July 29th, 2021

Emily Koide
Technical Advisor I
Nunavut Impact Review Board

Re: Agnico Eagle's response to Meadowbank (03MN107) and Whale Tail (16MN056) 2020 Annual Report comments

Figure 3. Development and Application of Monitoring Thresholds and Triggers for Water Chemistry Variables

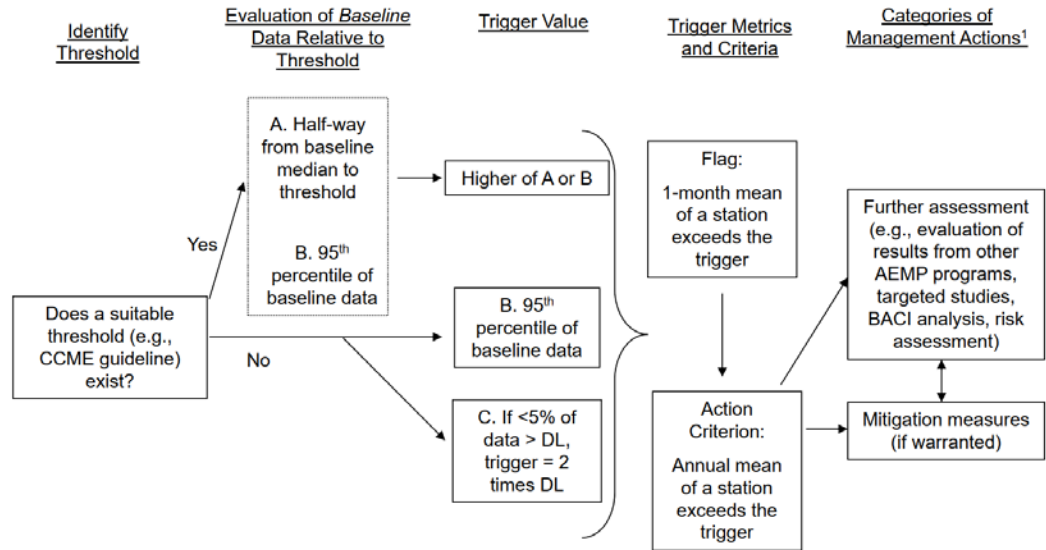
Agnico Eagle would like to refer to responses submitted on August 7, 2020 to NIRB: ‘Agnico Eagle’s response to Meadowbank (03MN107) and Whale Tail (16MN056) 2019 Annual Report comments’

The approach to evaluating short-term changes in water quality was first outlined in the CREMP Design Document 2012 (Azimuth, 2012). As depicted in Figure 3 from that report (see below), individual samples are screened against the trigger values each month to determine if there are short-term changes in water quality linked to activities at the mine. The monthly screening assessment is meant to “flag” parameters for closer examination in subsequent sampling events. If a threshold exceedance is detected (i.e., water quality guidelines), and if the exceedance is plausibly linked to activities at the mine, the Environment Department is notified to provide advanced warning of potential changes in water quality. It is important to reiterate that changes in water quality need to be evaluated relative to predicted changes provided in the Environmental Impact Statements for each Project.
